Re: Z.C. Case No. 24-15: Application of 901 Monroe Street, LLC (“Applicant” to the District of Columbia Zoning Commission for a Consolidated PUD and Related Zoning Map Amendment for Lot 23, in Square 3829 (the “Property”) – Applicant’s Pre-Hearing Submission

The Commission set down the Application at its February 13, 2025, public meeting. This filing provides responses to questions and comments raised by the Commission and to comments from the Office of Planning (“**OP**”) in its February 3, 2025, report (“**OP Report**”). In response to the questions and comments of the Office of Planning and the Zoning Commissioners, the Applicant provides the following information.

Discussion of Changes Made at the Roof Level

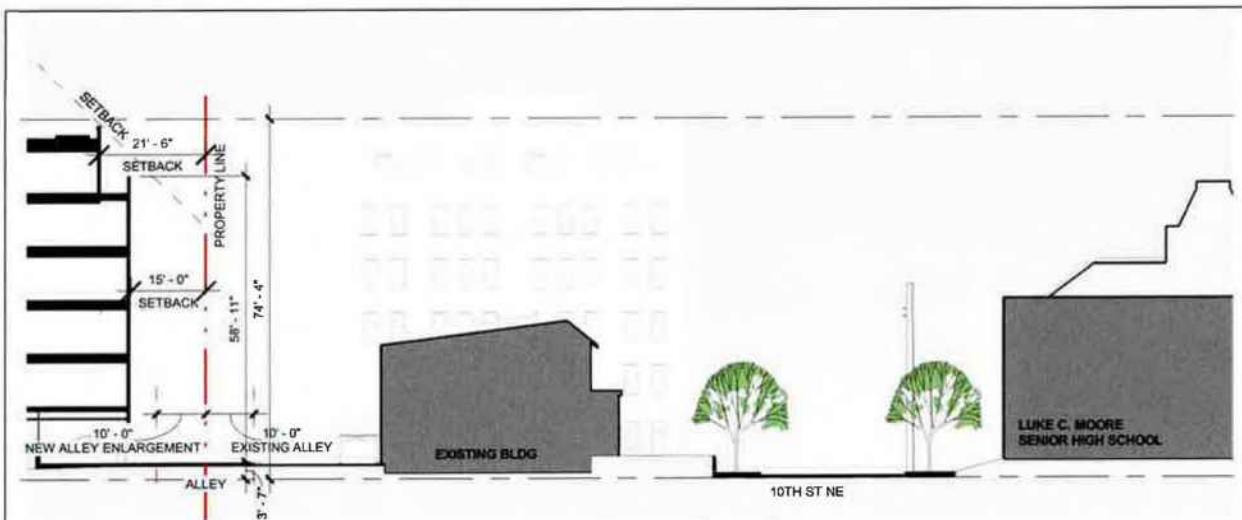
Since set-down, the Applicant has made changes to the roof level of the Project (See page 035 of Exhibit A). These changes include:

- The roof terrace has been relocated to the southwest corner of the roof to take advantage of views to the south;
- The mechanical penthouse and stair tower structures have been reconfigured based on the new roof terrace location (no Zoning Flexibility is required); and
- One of the screen walls has been removed.

Section diagram showing increased alley width and additional building setbacks (full height and upper level) from the west side of the rowhouses on 10th Street.

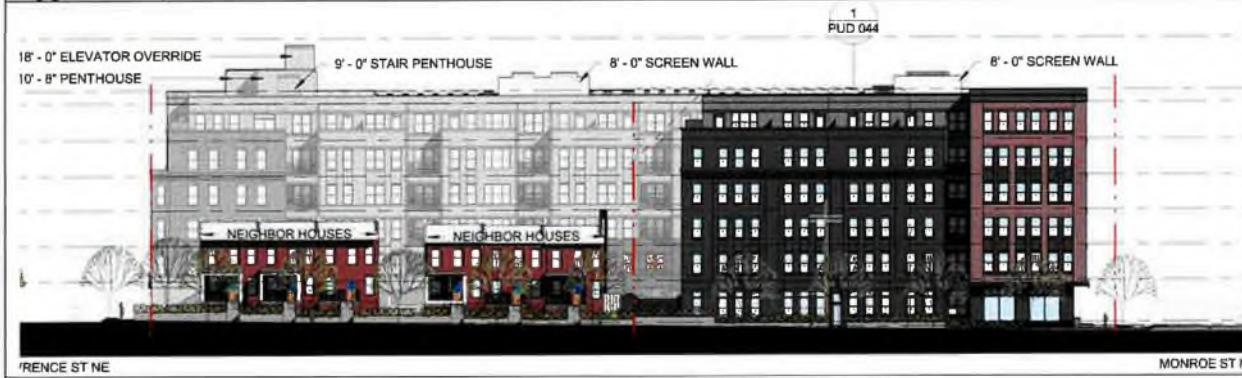
In response to the Commission's request for additional information regarding the Project's compatibility with the adjacent and nearby buildings and structures, the Applicant notes the special care that has been paid to the lower-scale residential uses along 10th Street, NE and Lawrence Street, NE, as evidenced in the building section and elevation drawings below.

Regarding the six rowhouses immediately south of the PUD site along 10th Street, NE the entire building is set back approximately 15 feet from the property line that is shared with the closest rowhome to the south, as well as from the public alley that separates the PUD site from the rear lot lines of the rowhomes. Additionally, the top floor of the building is set back approximately

seven feet along the east and south facing facades closest to the rowhomes. As shown in the attached Exhibit B, the relationship between the Project and the adjacent lower scale uses, including the rowhomes along 10th Street, NE, is similar to the relationship found at the Monroe Street Market PUD to the west of the Metrorail tracks. It is also similar to the relationships found at similarly situated PUDs near transit that are within NCAs and adjacent to lower-scale residential neighborhoods.

INCLUSIONARY ZONING UNITS (IZ)

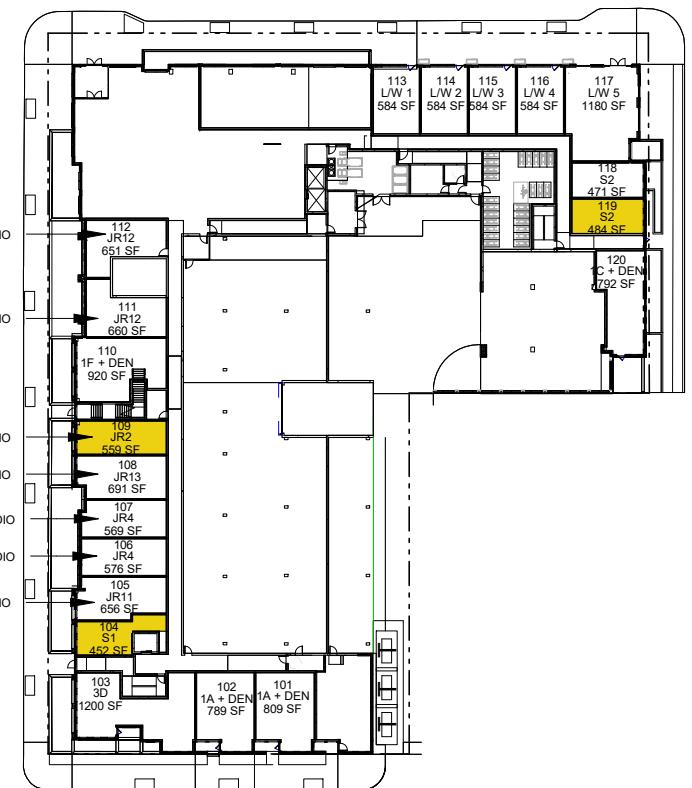
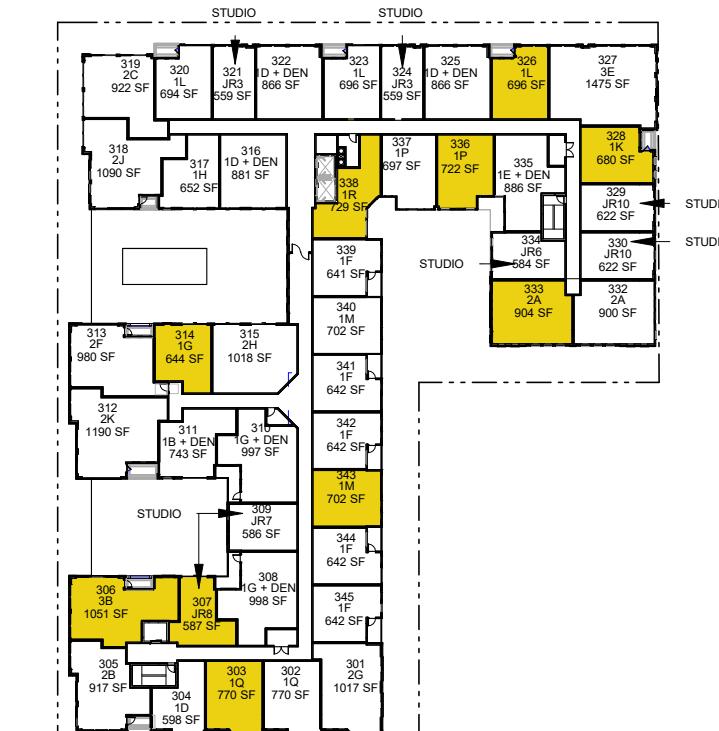
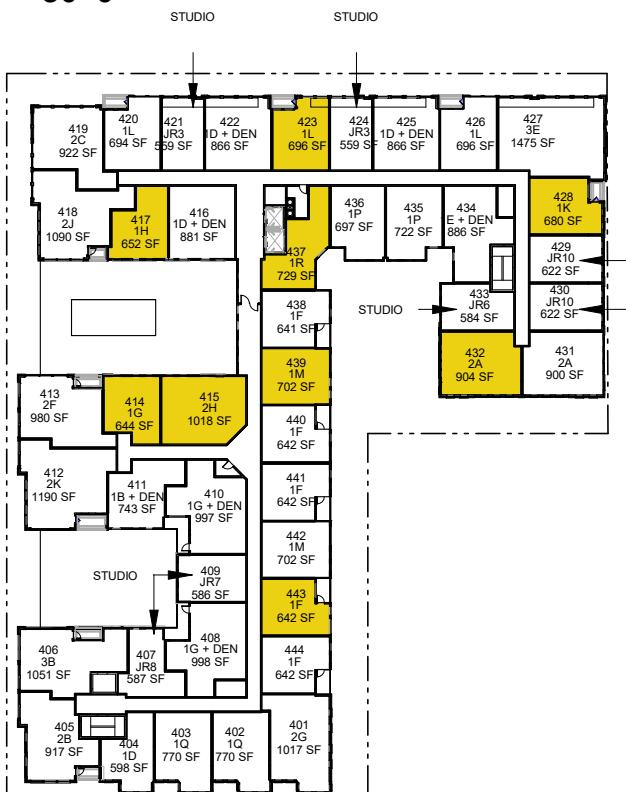
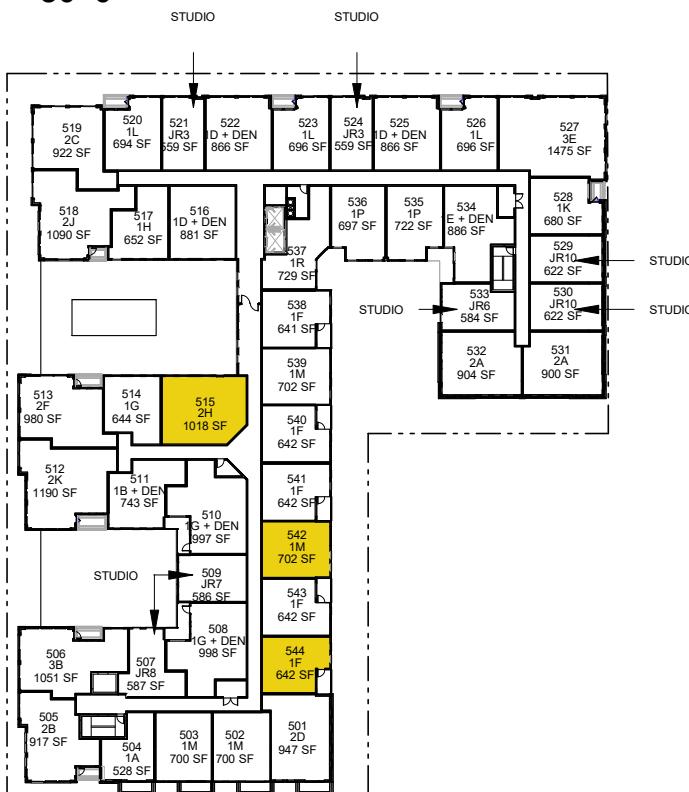
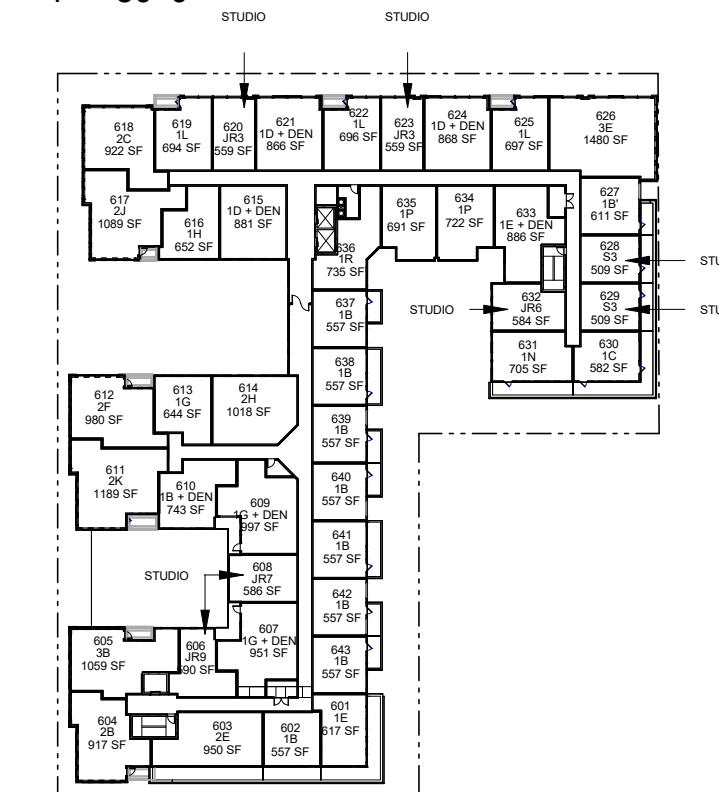
A plan depicting the location of the IZ units and a breakdown of the IZ units by unit type is provided on page 016 of Exhibit A.
